MINISTRY OF TRANSPORTATION  
Structural Section  
1201 Wilson Avenue  
Atrium Tower, 4th Floor  
Downsview, Ontario, M3M 1J8  
Telephone: 235-5507

## memorandum

RE: Contract 94-53 18 Mile Creek structures, Site No. 18-19, Burlington District

PLEASE FIND ATTACHED FIVE COPIES  
OF GT-685-2 FOR SOIL STABILIZATION  
ALREADY SUBMITTED TO YOU. THE DRAWING  
WAS NOT DUELY SIGNED BY P.ENG.  
THEY ADDED A NOTE FOR SPACING  
TO BE INCREASED TO 2.5 FOR N.S. ROAD  
STR. PLEASE REVIEW THE DRAWING  
AND SEND ME A COPY APPROVED  
BY YOU.

drawn/dessiné	date	checked/vérifié	date	scale/échelle
	JAN 12, 96	D.M.H.	JAN 12, 96	AS NOTED
<b>GEOTEC CONTRACTING LTD.</b> P.O. Box 37 Agincourt, Ontario M1S 3B4 Phone (416) 321-5907 QEW/18 MILE CREEK - CONT 04-53 SOIL STABILIZATION				GT-685-2

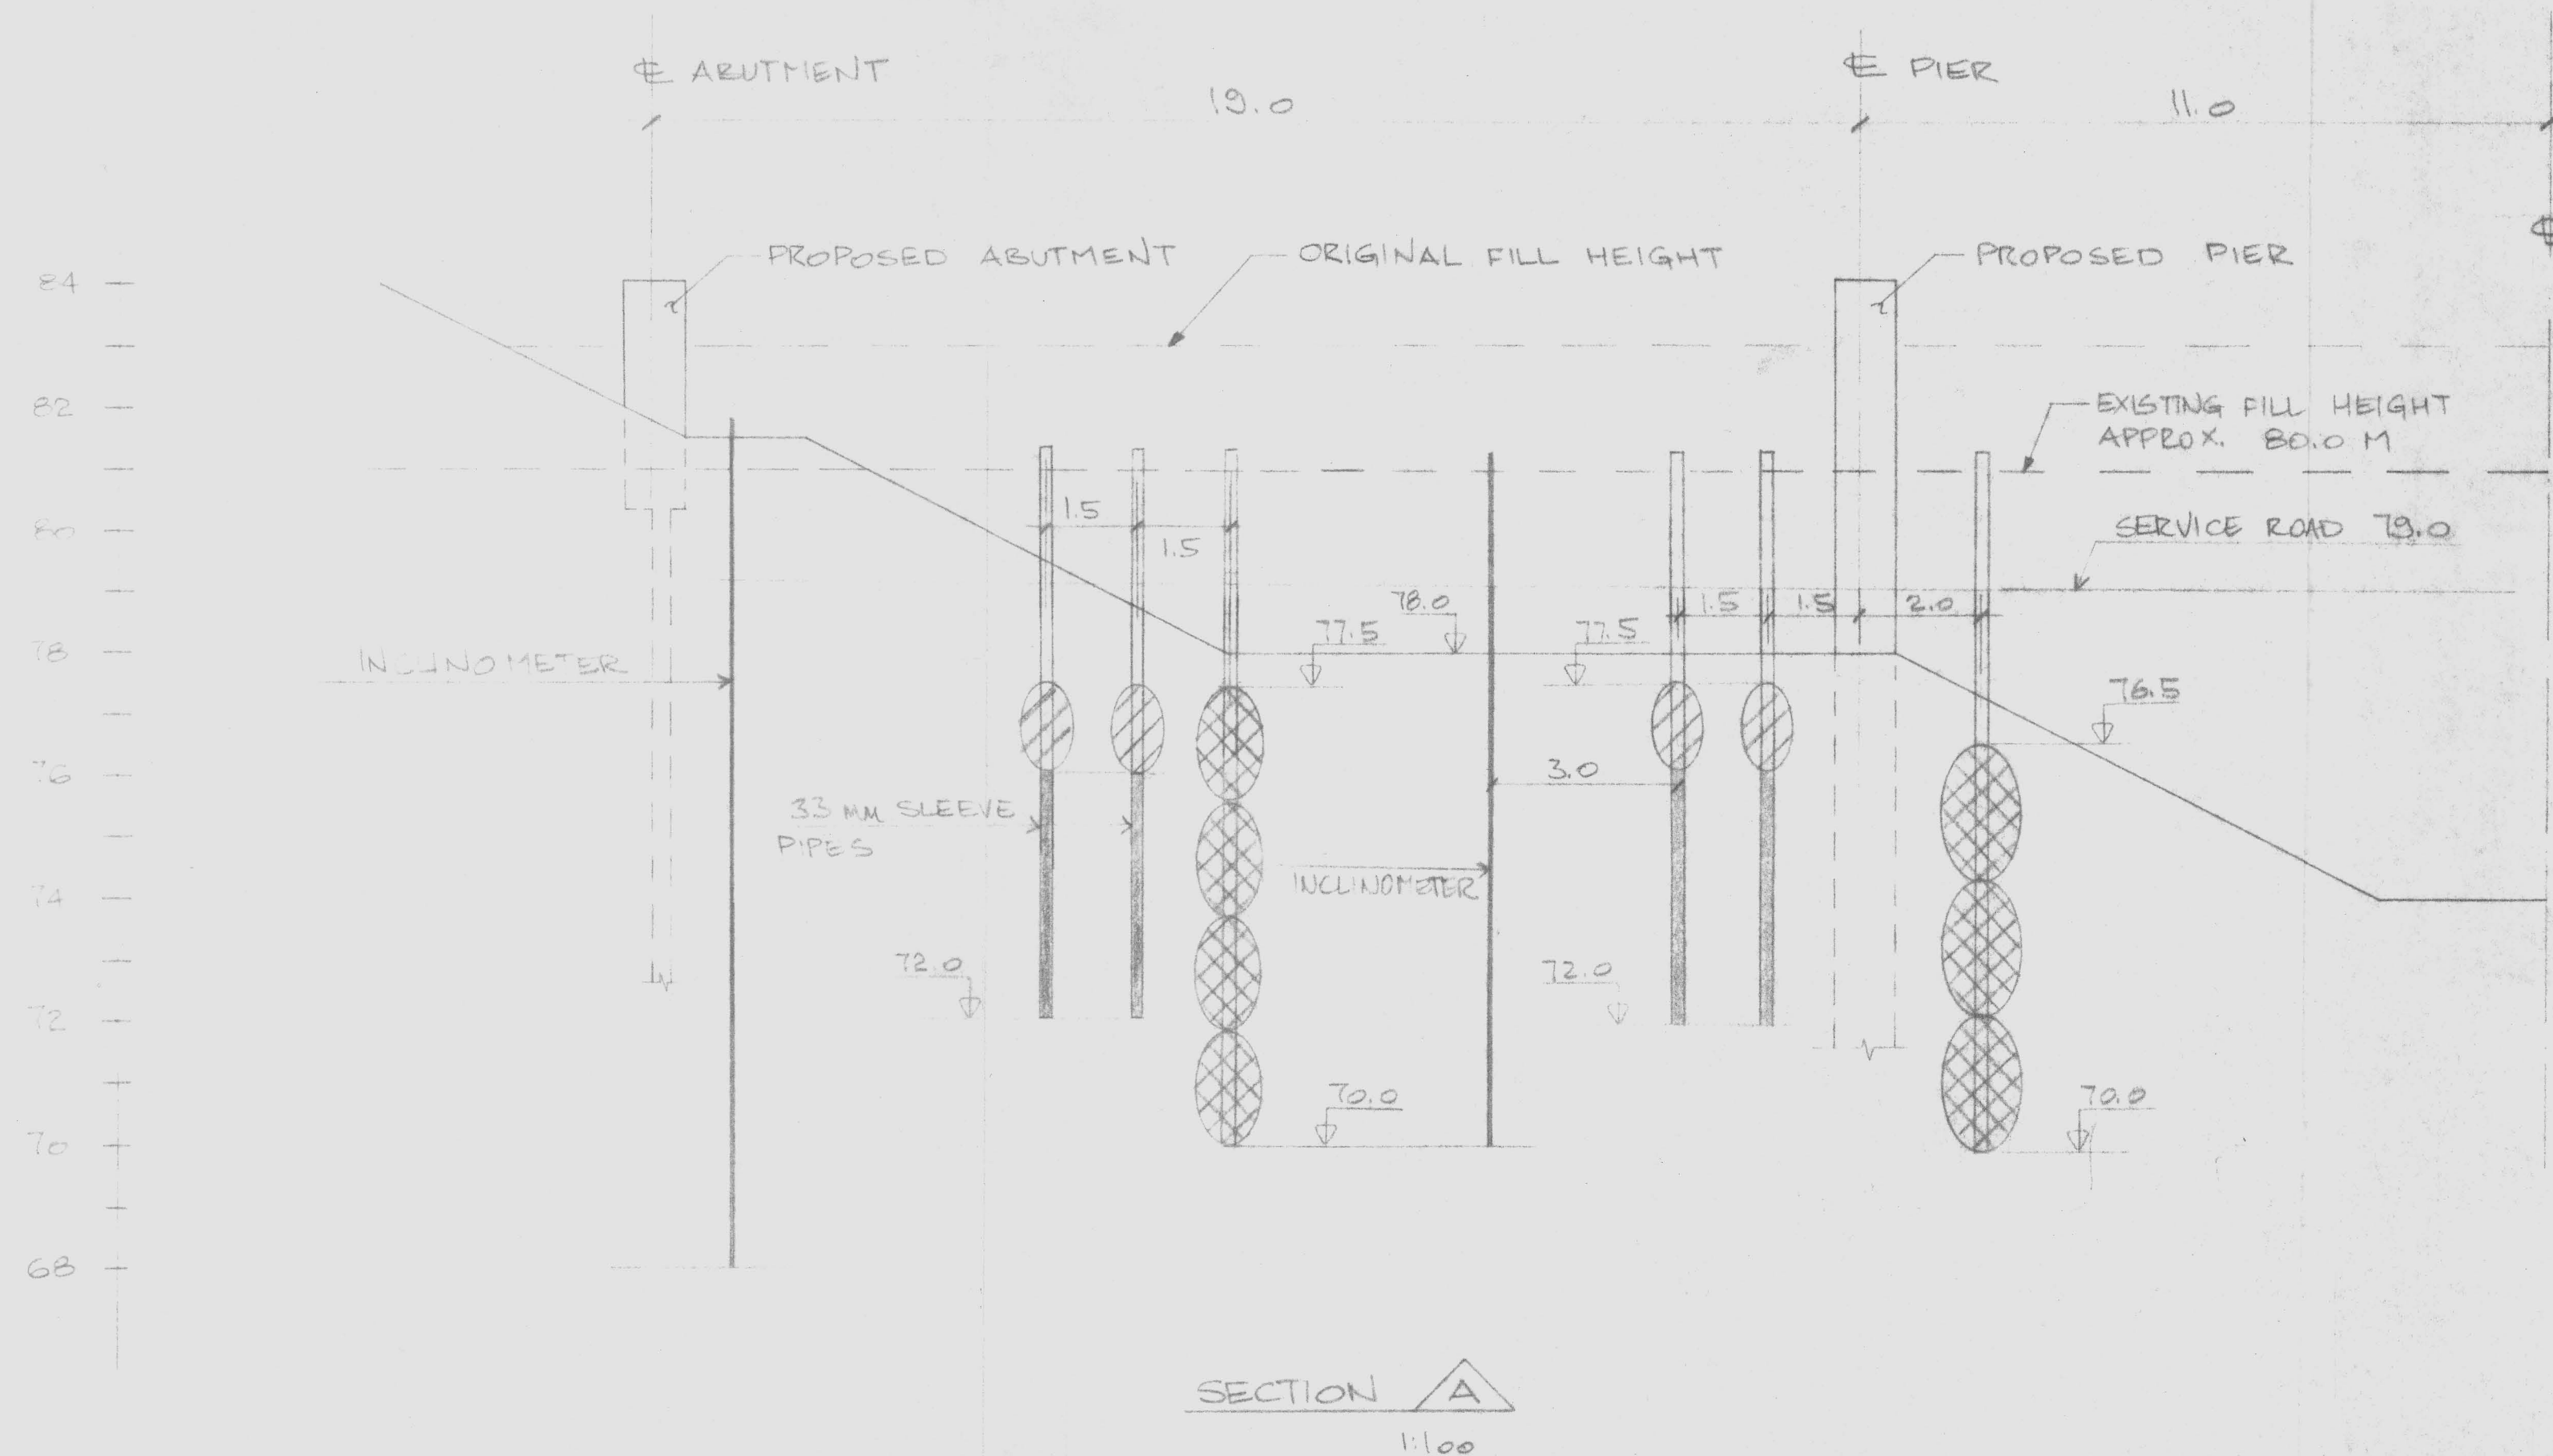
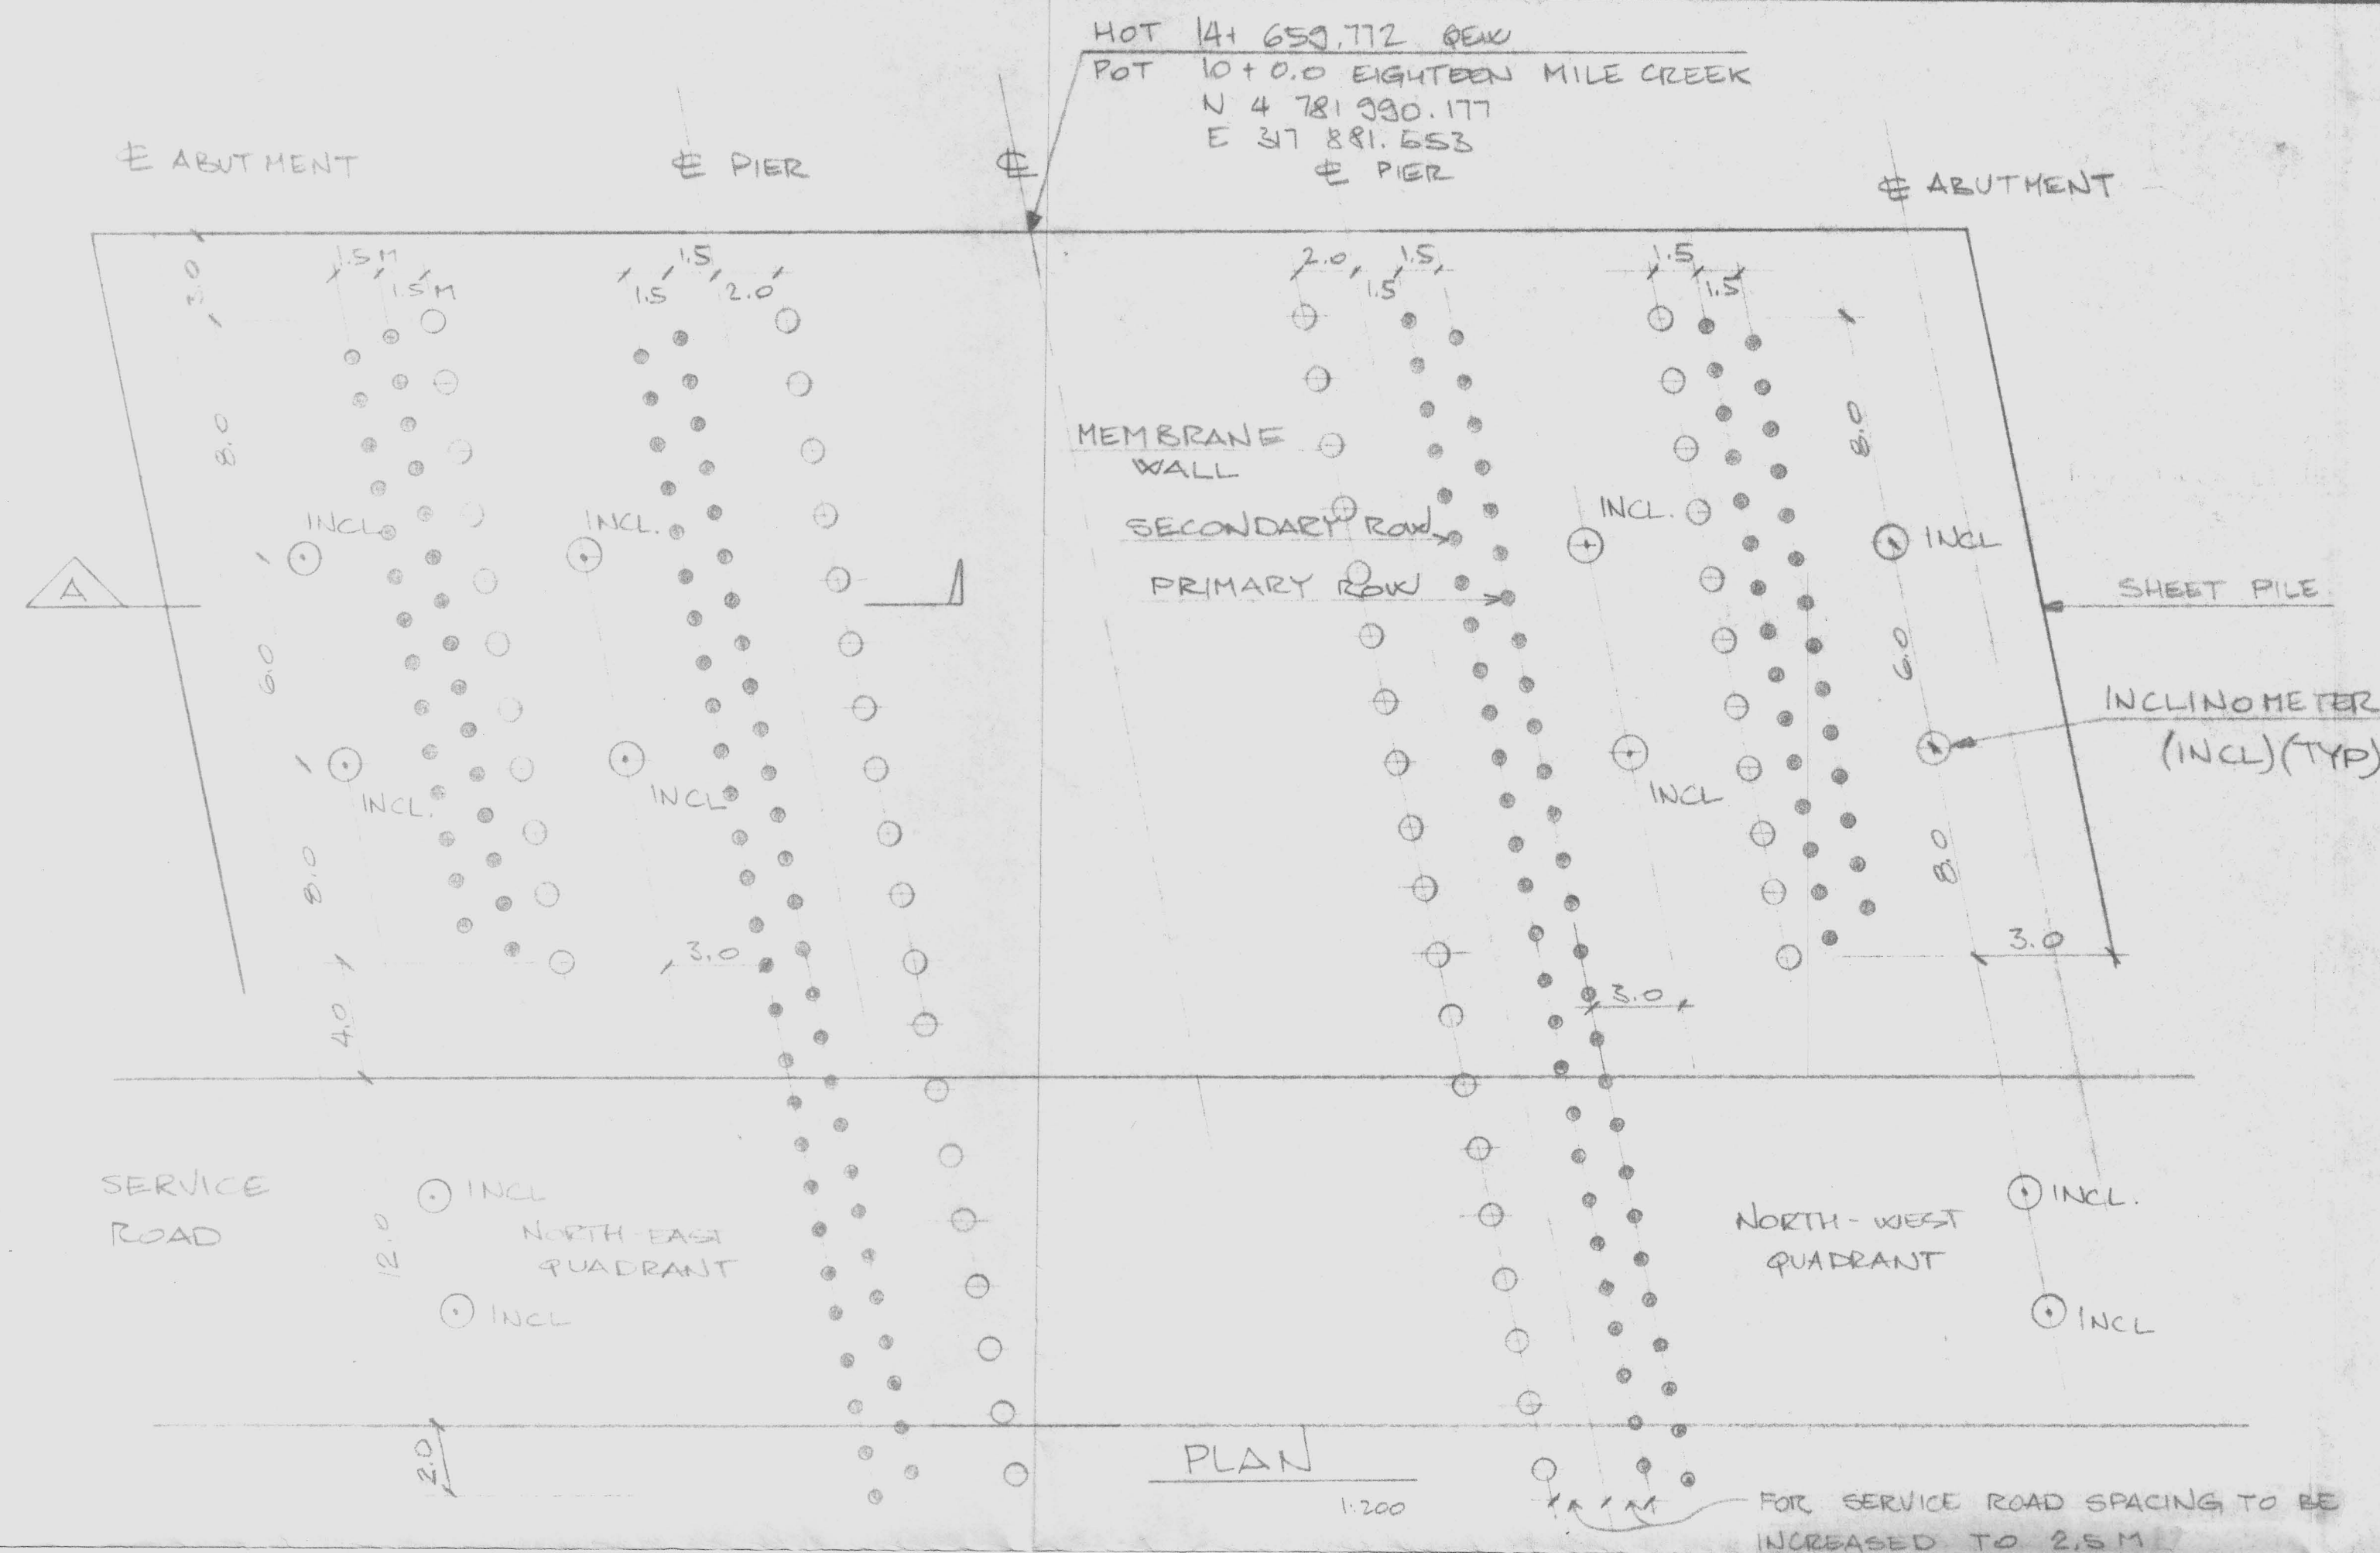
During my site visit on February 2, 1996, I noticed that a soil anchor at the west side of the sheet piling wall was installed at the wrong location. The soil anchor was installed at approximately 3.8m from the end wall at the west side rather than 2.5 m from the same location as shown on the approved roadway protection drawing. Please discuss this matter with the Contractor and request the Contractor to submit a remedial work proposal. Meanwhile, the Contractor is not allowed to proceed with the excavation work at the front of the sheet piling wall until this matter is resolved.
